Structural Assessment

Caruso Engineering LLC
5545 Wilson Mills Rd Ste 106, Highland Heights, OH 44143
info@caruso-eng.com - (440) 510 5030 - www.caruso-eng.com

Client: SAMPLE CLIENT Site Visit Date: DATE

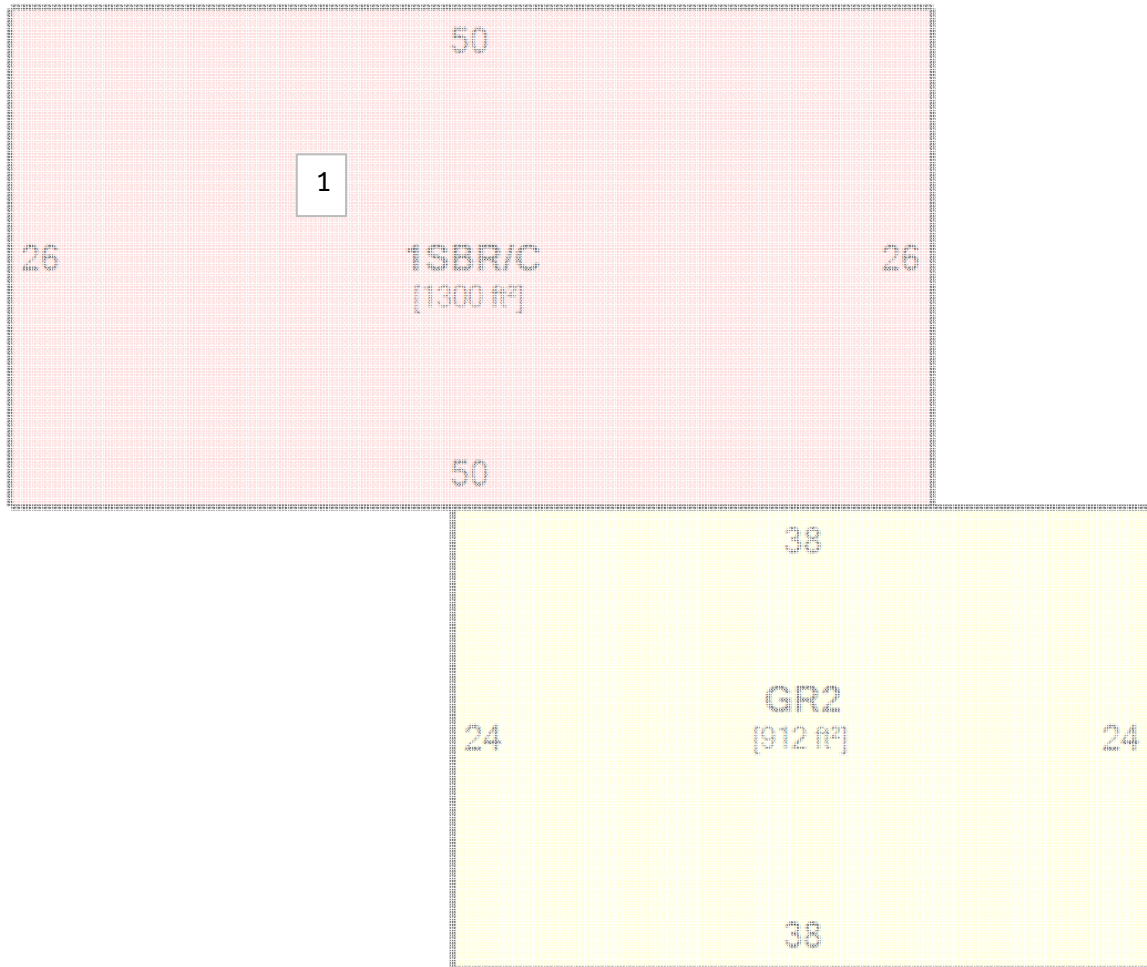
1,2	Sagging hallway/living room floor and interior drywall cracking are due to a sagging crawlspace beam. Crawlspace was entered in January to confirm beam condition - was not entered in this visit.
3,4	Exterior brick façade cracking due to corrosion of steel lintel. Separation of CMU backing at the lintel elevation was observed. The section of wall above the lintel has been pulled out likely due to wind suction pressure. Wall and façade are currently stable, but the situation could change quickly.
5,8	Over-spanned lintel has led to cracking in the brick façade. Yard in this area is very wet. Plans for a french drain were noted on site. Drainage in this area is critical to mitigating potential settlement (see item 9).
6	Over-spanned lintel has led to cracking in the brick façade. Since façade height above windows is short and there are several windows in succession, the top facade courses are separating from the wood frame wall sheathing across the whole back of the house.

7	Over-spanned lintel has led to cracking in the brick façade.
9	Exterior wall observed to be leaning out at the top. Potential settlement cracking also observed in the closet and around the window. Standing water noted in the yard (item 8). This area may have experienced moderate settlement in the past.
